CLASS II PERMISSIVE CHANGE REQUEST

RE: Class II Permissive Change Request
FCC ID: 2AL64-RE667-PRO
IC ID: 24702-RE667PRO

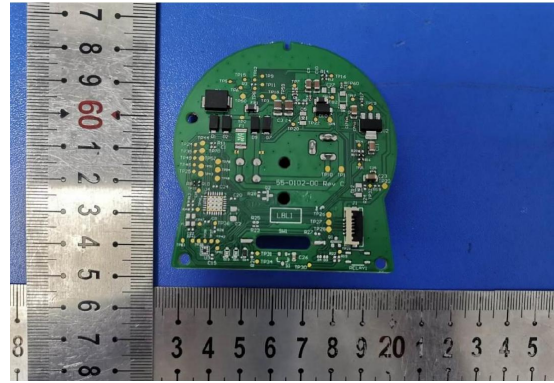
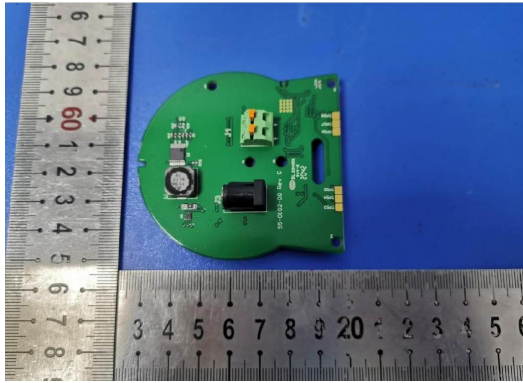
1. Substitution of the flash IC (U4000) from H27UBG8T2DTR-BC to EMMC16G-TB28.
Old IC:H27UBG8T2DTR-BC

New IC:EMMC16G-TB28

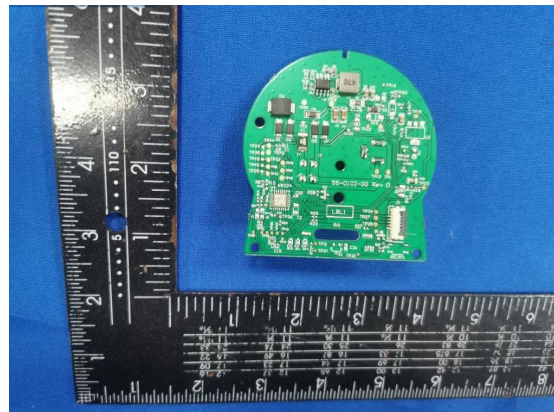
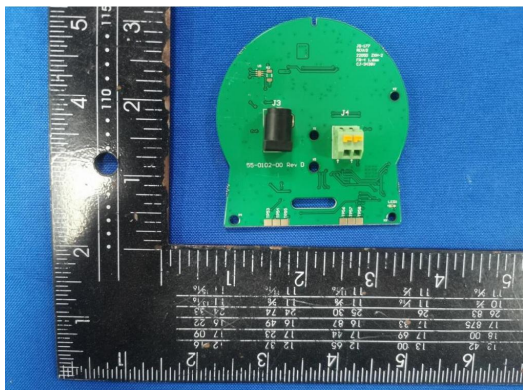
2. Power boards re-designed.
Old Power boards:

New Power boards:

Based on above that the AC power line conducted emissions and emissions in restricted frequency bands including band edge are re-assessed.
